P 85967

SEWAGE DISPOSAL SYSTEM

MARYLAND STATE DEPARTMENT OF HEALTH

SUBDIVISION _____ ROAD 621 Gaither Road LOT Parcel A

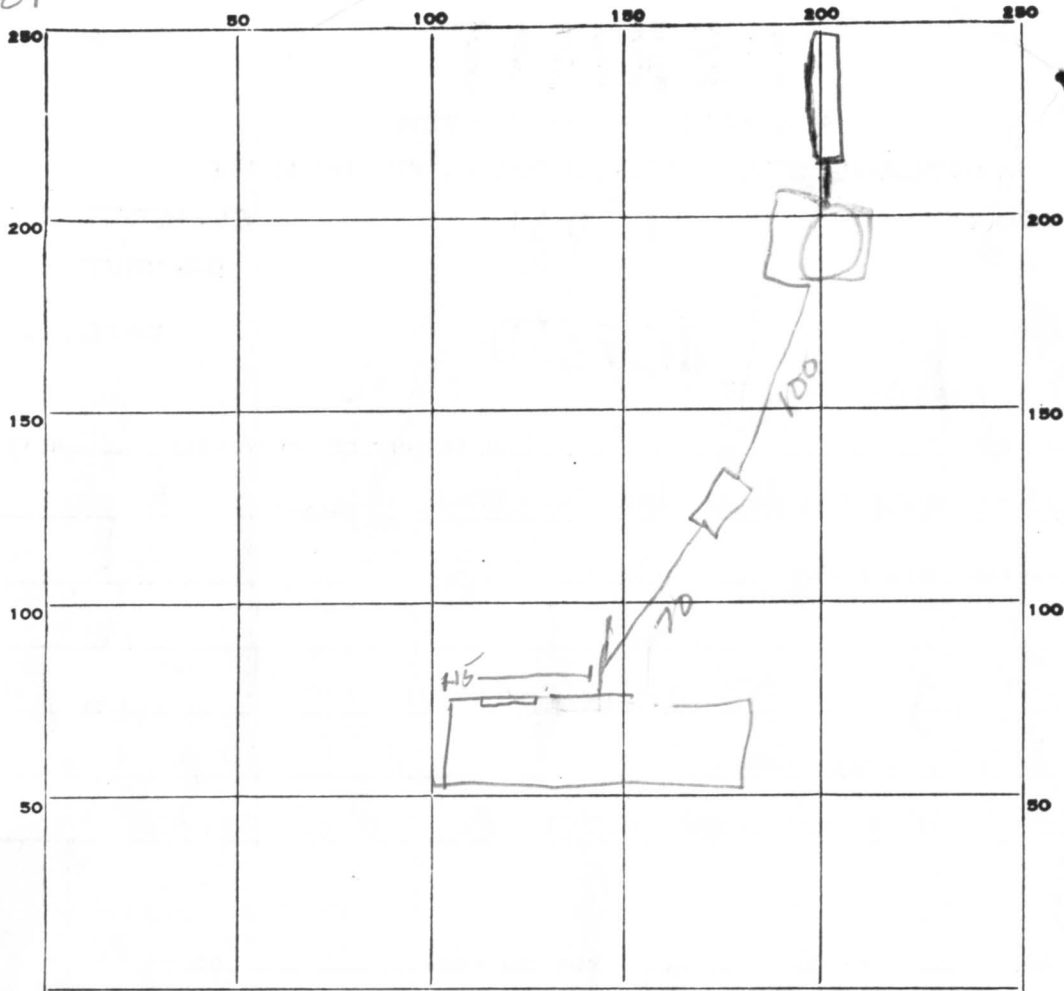
OTHER DRY WELL AND TRENCH - Dry well to have 300 sq. ft. absorbent sidewall area. Inlet at 4½ ft. and maximum depth 10½ ft. below original grade. Locate dry well 40 ft. off right lot line, and 245 ft. from front property corner at left of driveway (see plat) as seen from Gaither Road (perc hole #6). Trench to be 23 ft. long for a total side-wall area of 135 sq. ft. Run trench off rear of dry well and parallel to right lot line which is 154.05 ft. long (see plat) towards perc hole #17. Inlet of trench to be 4½ ft. and maximum depth 10½ ft. NOTE: CALL FOR INSPECTION OF TRENCH BEFORE PLACING STONE IN TRENCH. NOTE: ALL PIPE FROM HOUSE TO DISPOSAL AREA MUST BE CAST IRON. PERMIT VOID AFTER THREE YEARS. NOTE: INSTALL STAND PIPE ON SEPTIC TANK AND DRY WELL. STAND PIPES MUST BE 6 INCHES IN DIAMETER. CAST IRON, CONCRETE OR TERRA

REMARKS Trench depth not seen no buffer seen
Stop work - RB 9/15/77
